DEPARTMENT OF TRANSPORTATION**National Highway Traffic Safety Administration****49 CFR Part 571**

Federal Motor Vehicle Safety Standards

ACTION: Final rule.

§ 571.305 Standard No. 305; Electric-powered vehicles: electrolyte spillage and electrical shock protection.

Figure 1. S7.6.3 Measurement Location For Vb Voltage

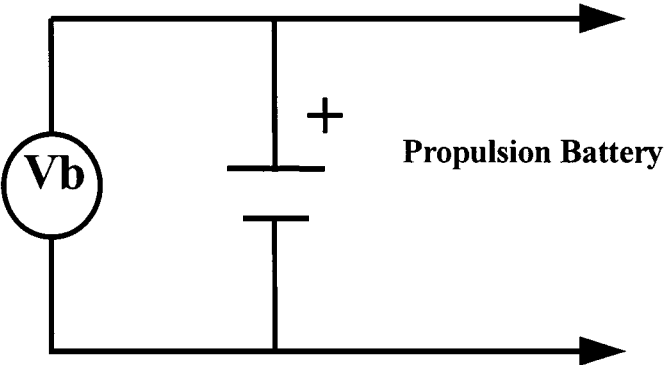
GM called our attention to typographical or technical corrections that should be corrected in the final rule. We have done so. In Figure 1, the description is revised to "Measurement Location for Vb Voltage." In Figure 3, the symbol within the circle is "V2" rather than "Vb." In Figure 4, the equation for Ri is revised to:

Figure 5. S7.6.7 Measurement Location For V2' Voltage

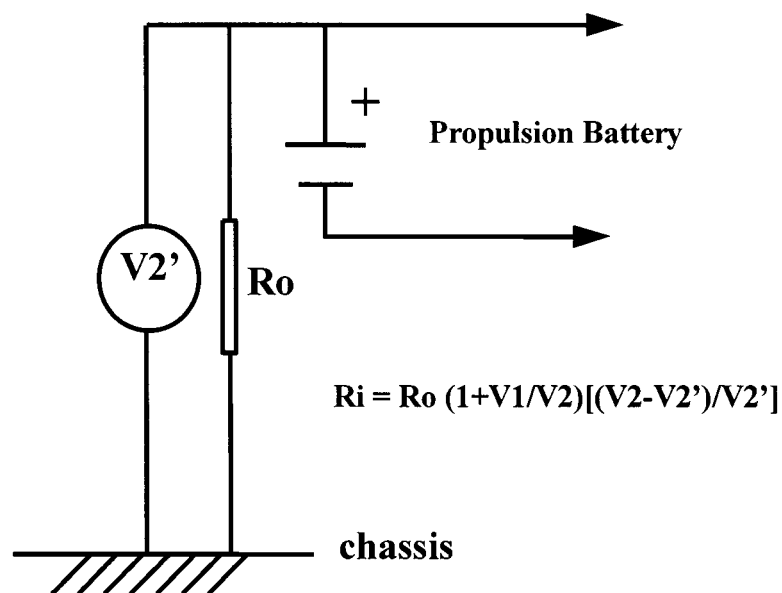
In Figure 5, the equation for Ri is revised:

$$R_i = R_o[1 + (V_1/V_2)][(V_2 - V_2')/V_2']$$
